ONE UTAH CENTER

RE: RESPONSE TO INITIAL COMPLETENESS REVIEW COMMENTS, RILDA CANYON LEASE TRACTS, PACIFICORP, DEER CREEK MINE, ACT/015/018, FOLDER #2, EMERY COUNTY, UTAH

PROBABLE HYDROLOGIC CONSEQUENCES (PHC) REVIEW, PACIFICORP, DES BEE DOVE MINE, ACT/015/017, DEER CREEK MINE, ACT/015/018 (INCLUDING THE PROPOSED RILDA CANYON LEASE TRACT), COTTONWOOD/WILBERG MINE, ACT/015/019, FOLDER #2, EMERY COUNTY, UTAH

RE: DOGM's review of the Probable Hydrologic Consequence (PHC), memo dated February 6, 1992

COTTONWOOD CANYON WELL DESIGN - COLLUVIAL DEPOSITS FIGURE 1

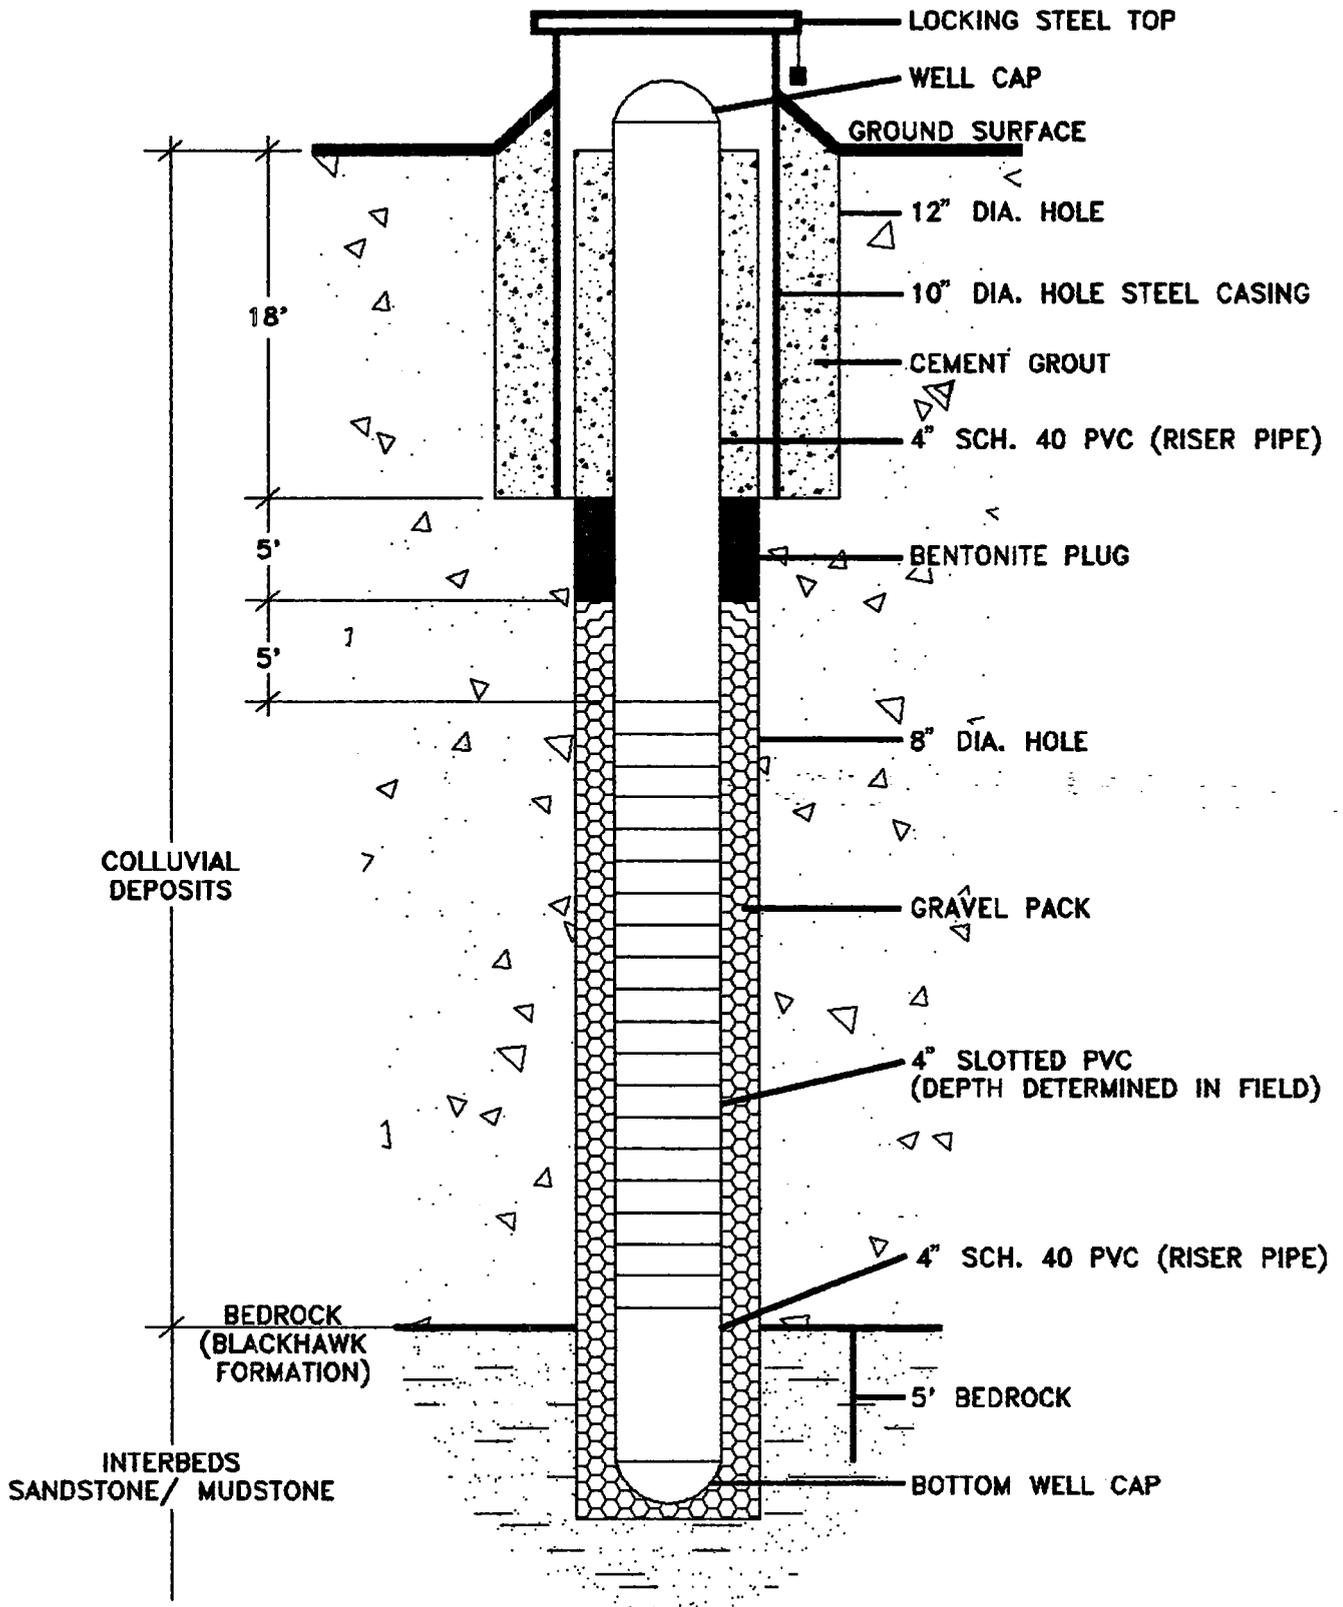
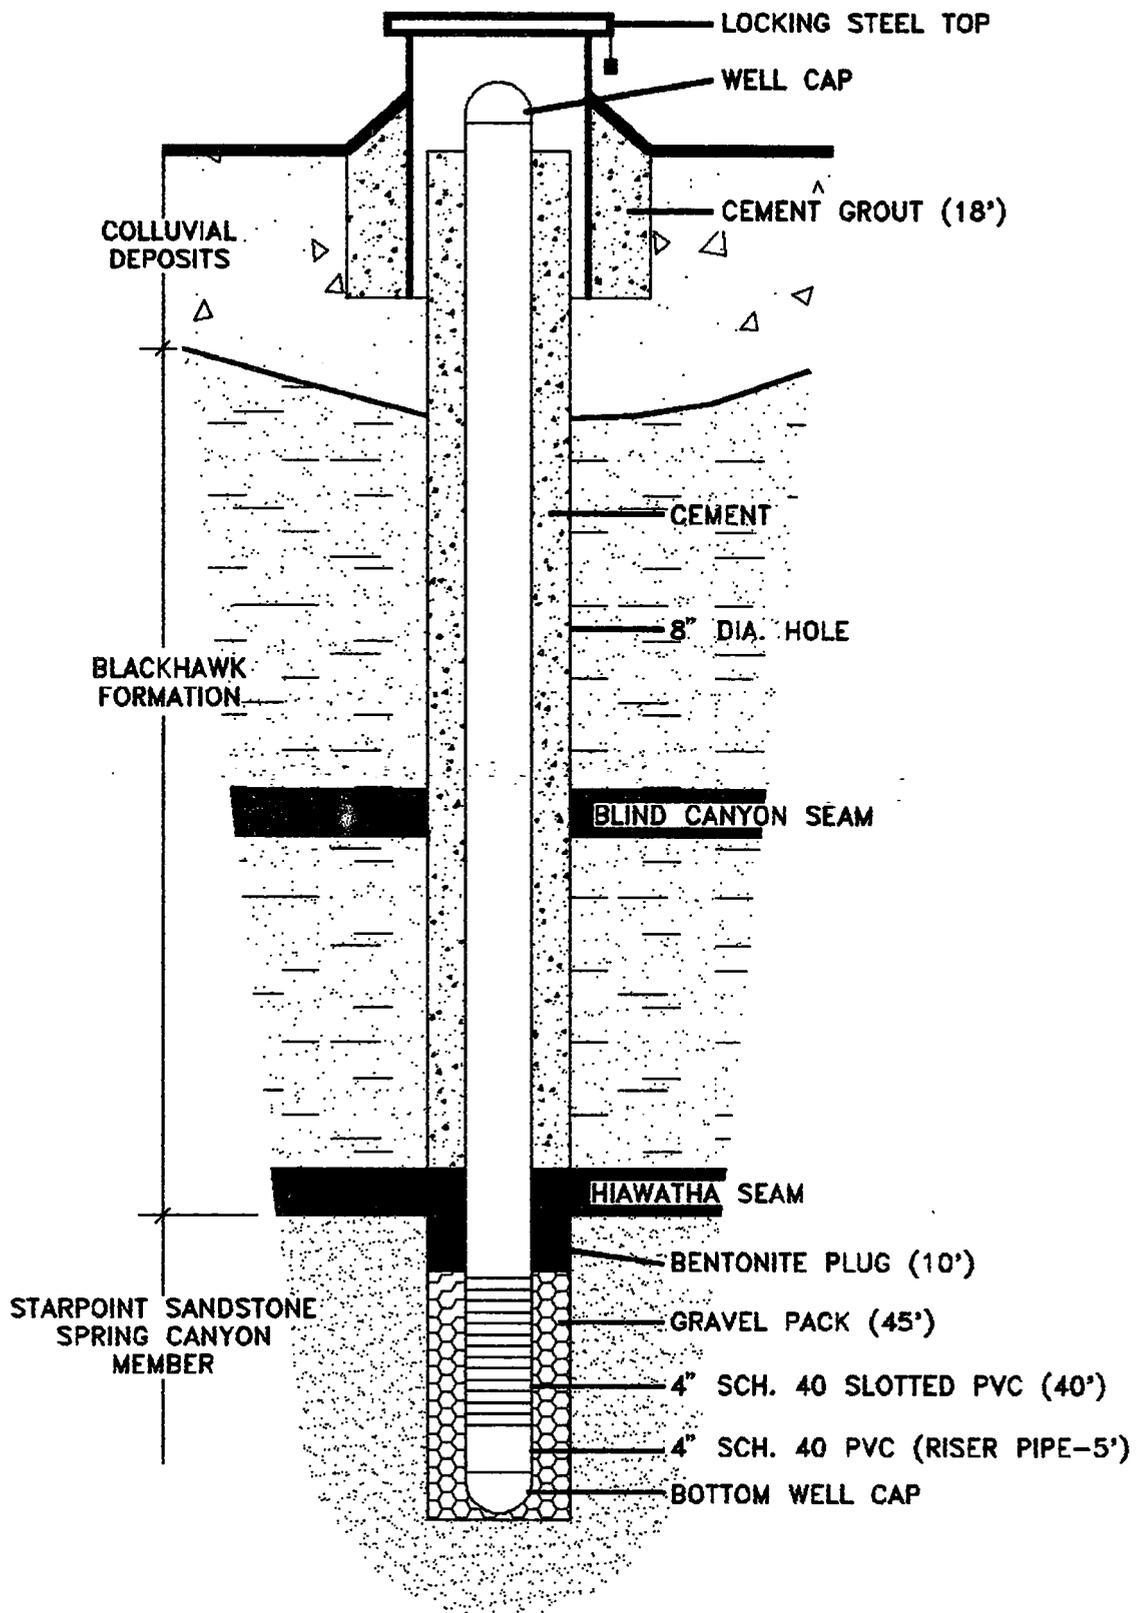
In regards to the Rilda Canyon lease area, north of the Graben, the operator has not provided any seasonal baseline (quality and quantity) groundwater data on the aquifers above the coal seam, within the coal seam, and below the coal seam in this lease area. The lease addition cannot be approved until this necessary hydrologic and geologic data is available to the Division.

COTTONWOOD CANYON CREEK MONITORING WELL DESIGN

(See Figures 1 and 2)

A. Construction Standards

- (1). At least 18" above ground level (ground surface will slope away from casing)
- (2). Minimum wall thickness
 - ▶ 10" surface casing = 0.250"
 - ▶ Depth, minimum 18'

- (1). Minimum wall thickness
 - ▶ 6" riser pipe = 0.316"*
 - ▶ 6" slotted = 0.316"*

Overburden - unconsolidated, permeable

Minimum grouting depth - 18 feet to surface

Minimum non-perforated casing depth - below lowest pumping level

3. Filter material shall consist of clean, well-rounded grains that are smooth and uniform.
